Reactor Controls, Inc.

Subject: Your letter dated August 8, 1983 and
"Draft of IN83-XX" Reactor Controls, Inc.
Construction Deficiencies

Response to Comments on Zimmer

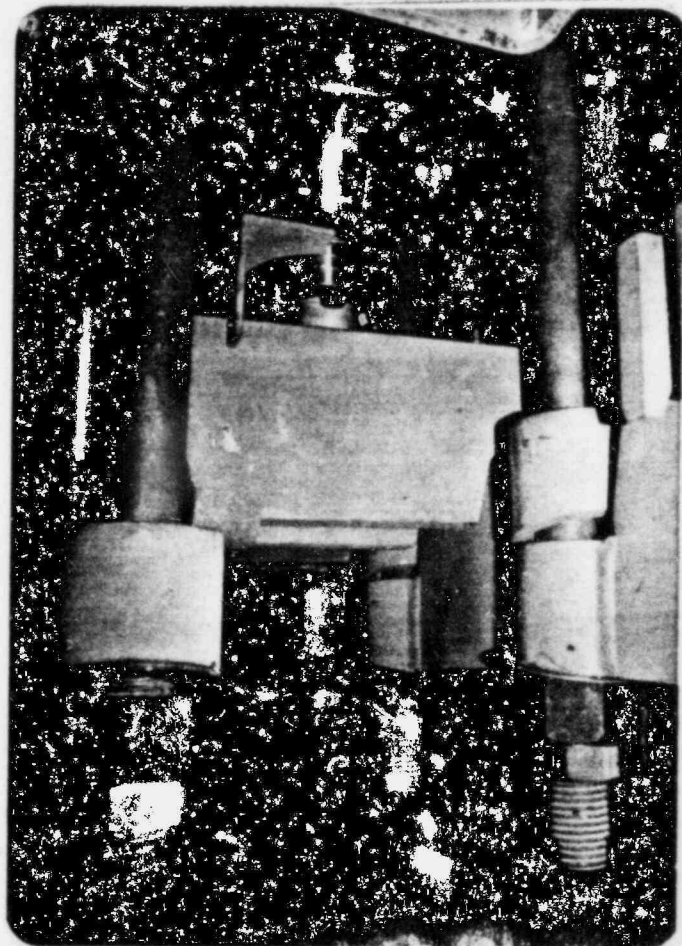
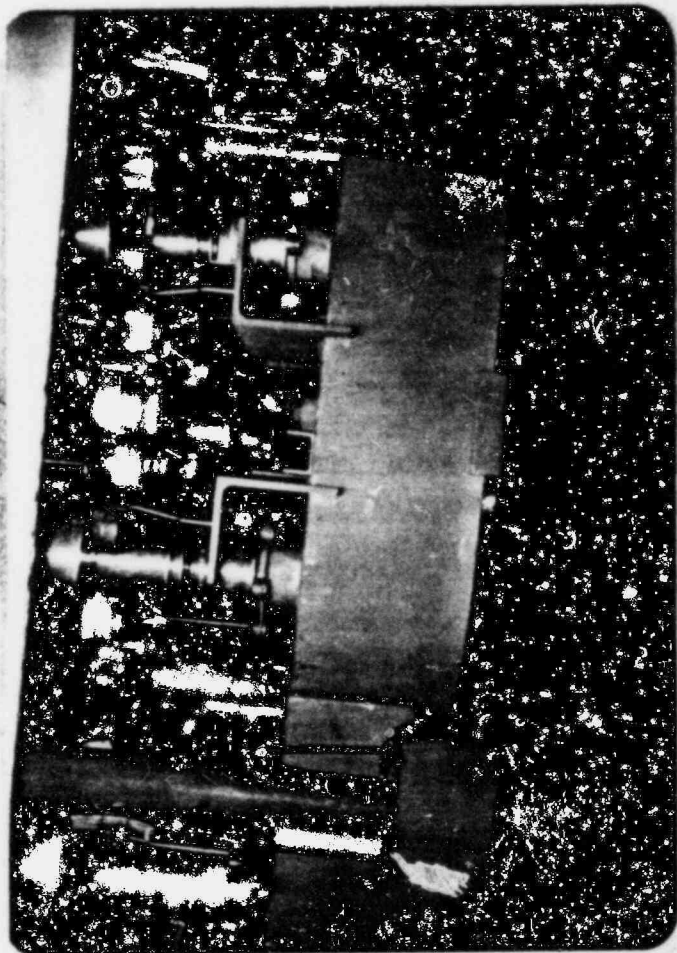
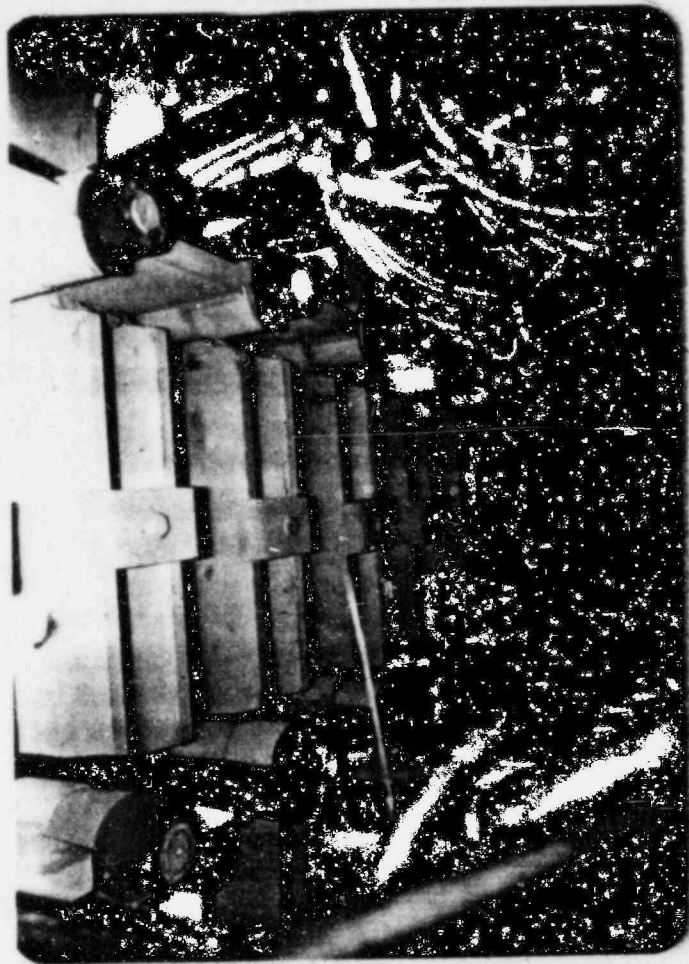
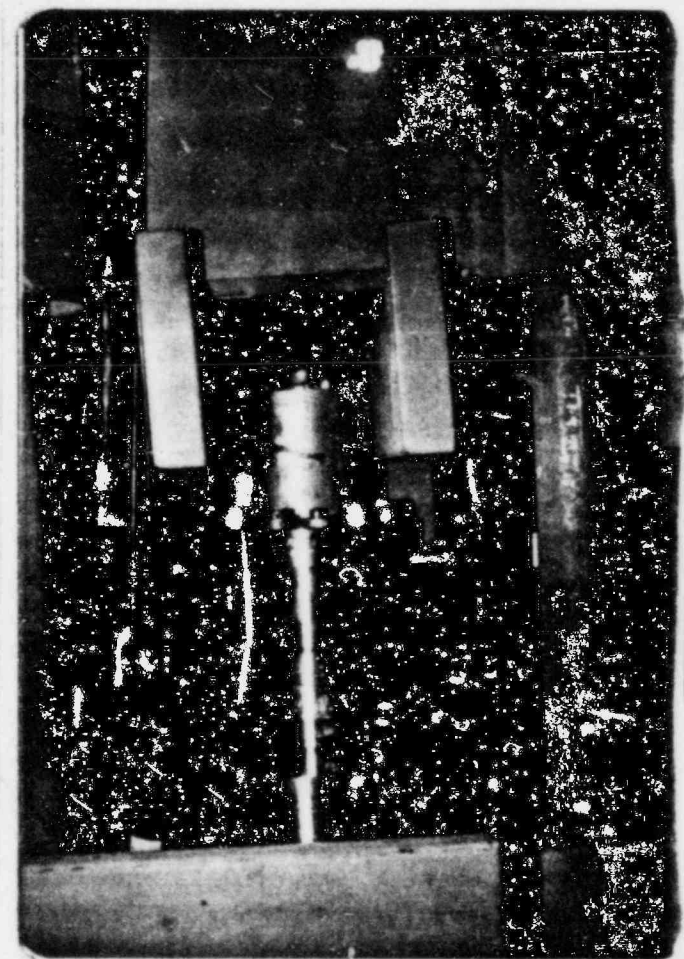
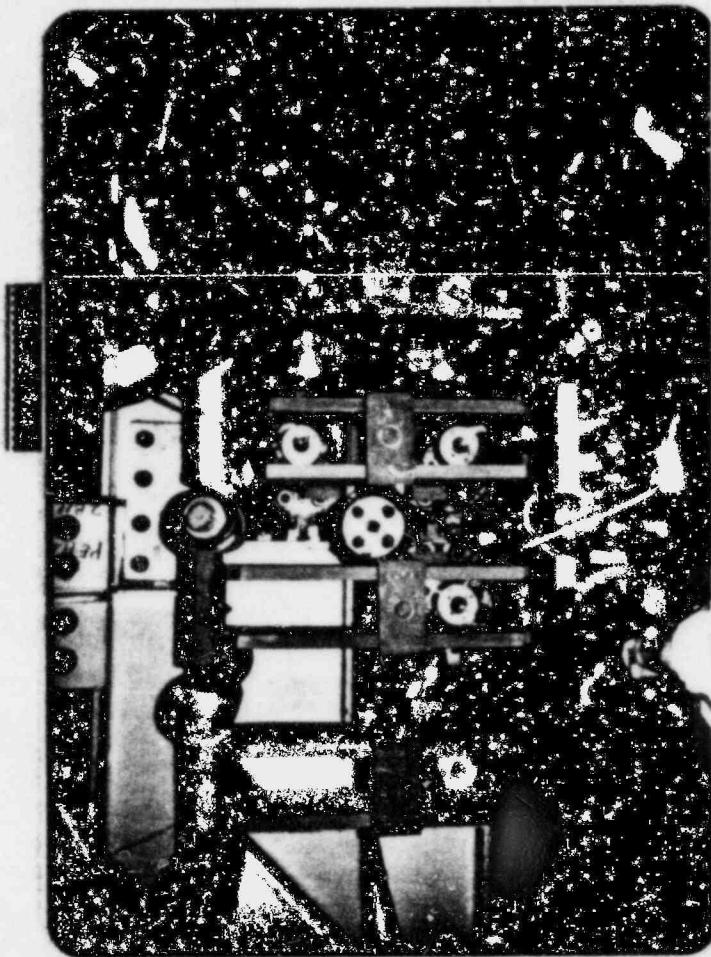
- a. This assembly was installed as designed and supplied. Attached are pictures of this type of assembly in the Hatch Nuclear Power Plant which is identical to Zimmer. A check of the G.E. Co. installation drawing revealed this is normal for this installation and the installation was in accordance with the drawing. A check with the component designer, G.E. Co., indicated this is the actual design of the component.
- b. RCI had no responsibility for surface treatment of the components. The supplier of the equipment provided the surface treatment.
- c. Keeping in mind RCI has been off site since 1979, the fact a fillet weld is cracked at this time is not evidence it was cracked at time of installation or that inadequate techniques were employed to perform the welding.

PROJECT NO. 761E970	REV. 2	DESCRIPTION NO. 1 SYSTEM CONTROL ROD DRIVE HOUSING SUPPORT	DESIGNED BY G.H. Cox	DATE: 4-5-75
CRD HOUSING SUPPORT	G.E.	DESIGNED BY G.E.	2784	29821

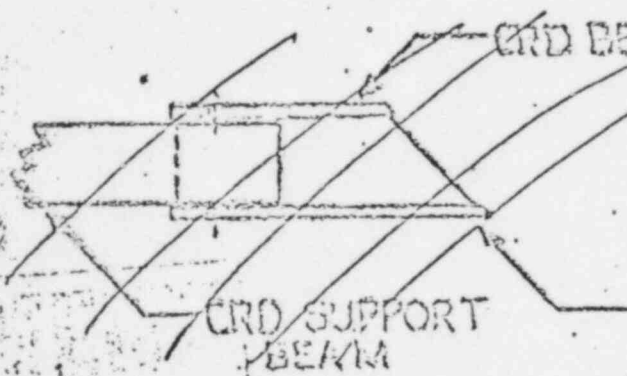
FIT UP PROBLEM WITH CRD SUPPORT BEAM BRACKETS & EMBEDDED SUPPORT PLATE.

I. BRACKETS #18, 21 & 22 TO LONG.

II. $\frac{3}{16}$ " GAP ON ONE SIDE OF BKT. #17 & EMB. PLATE & LURD.

~~I. BRACKETS #21, 22, 18 TRIM TO FIT SEE DETAIL B~~

II. BUTTER DIAB. PLATE TO CLOSE $\frac{3}{16}$ " GAP & WELD PER DETAIL C. BRACKET #17.

Per telecon R.J. Pruski.
FDR to be prepared
by GE will be
approved by SCL

TRIM AS REQUIRED TO FIT 9-9-75
EMBEDDED PLATE

BUTTER GAP
WITH WELD
METAL

SUBJECT CRD Support Beams and Brackets Ref Kn-1-13 dwg - 761E970 Sheets 1 and 2

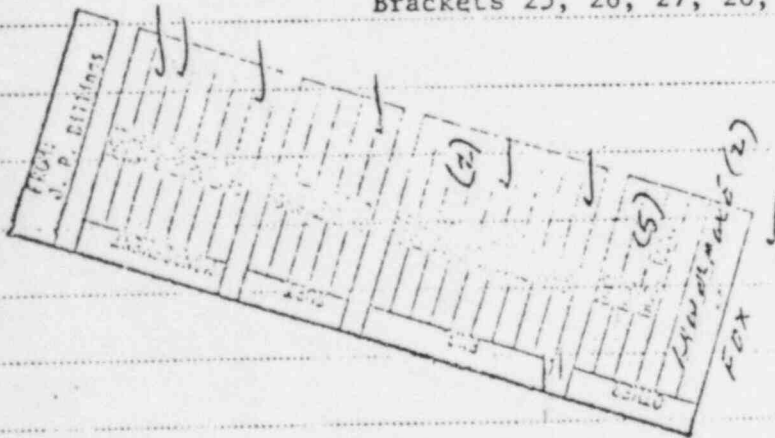
Due to imbedment problems, modification of General Electric supplied equipment is authorized as follows.

- Beam 3 Install 1/16 shim between bottom of beam and bracket # 11.
- Beam 6 Bracket 23 - cutoff 1/2"
 Bracket 24 - cutoff 7/16"
- Beam 2 Bracket 10 - cutoff 1/2"
 Bracket 11 - cutoff 1/4"
- Beam 7 Enlarge hole in beam so bolt will go through beam and bracket #18
 approximately 1/8".
- Beam 51 Bracket 21 cut long leg so bracket will fit on embedment not to
 exceed 1 1/2".
 Bracket 22 cut long leg so bracket will fit on embedment - not
 to exceed 1 1/2".
 Brackets 25, 26, 27, 28, may be cut or ground to fit.
